**RE: Saint Matthew Parish Gymnasium**

I reviewed the revised drawings for a somewhat smaller building than the previous proposal located between the existing Auditorium and the main pedestrian walkway into the parish complex. The existing structures in the complex provide the substantial context for this project. Other developments along El Camino Real are mixed in scale and design, and have little influence on this campus-like site. While there are single family homes to the north of the parish grounds, the proposed new gymnasium structure is relatively far removed from them, and should have little if any visual impact. Photos of the site are shown below.

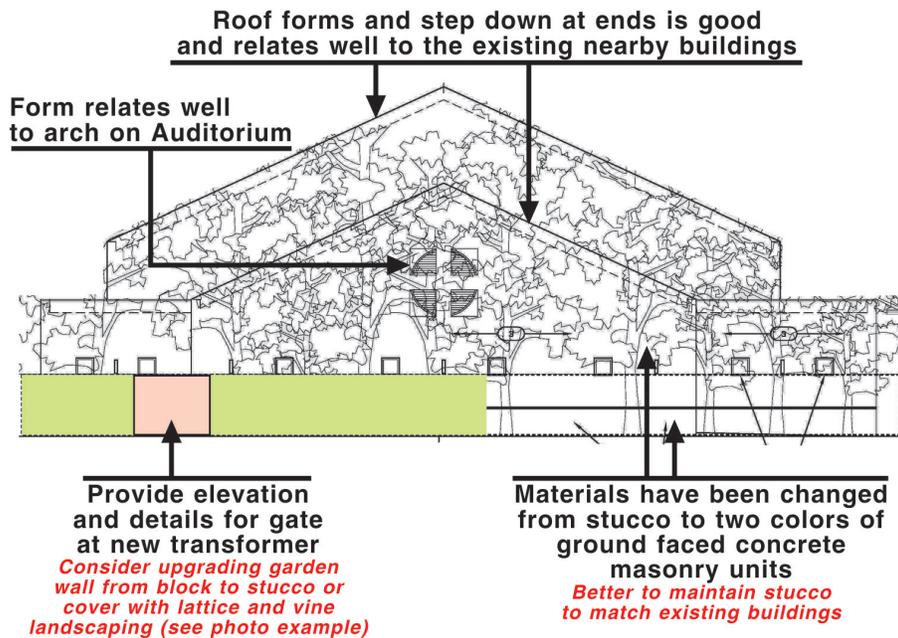
4. There is currently a rather unattractive chain link gate located at the juncture of the above referenced garden wall with the Auditorium (see photo to the right). It would be desirable, as part of this project, to eliminate, relocate, or replace this gate with a more attractive gate more in keeping with the design and character of the buildings.

Current location of unattractive chain link gate - Will it be removed or replaced?

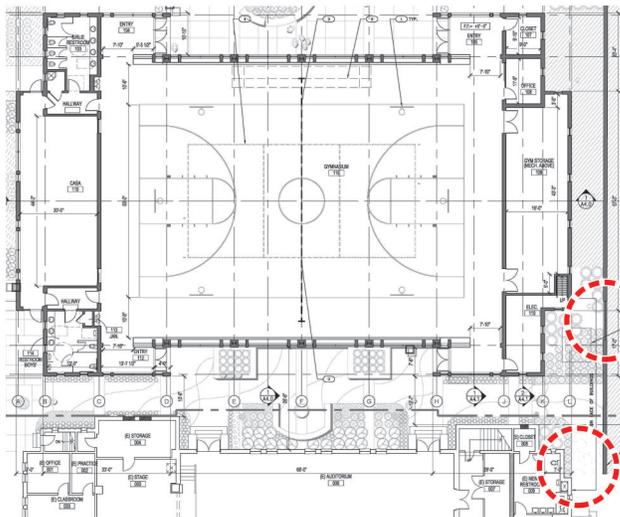
3. The existing garden wall along the El Camino Real property line is proposed to remain. The wall is not currently very attractive, and tends to negatively impact the otherwise strong visual quality of the Auditorium and El Camino Real streetscape. It would be desirable to finish this wall with stucco to match the existing buildings and the new structure. Alternatively, vine landscaping could be installed over the existing wall. One example is shown in the photos below.
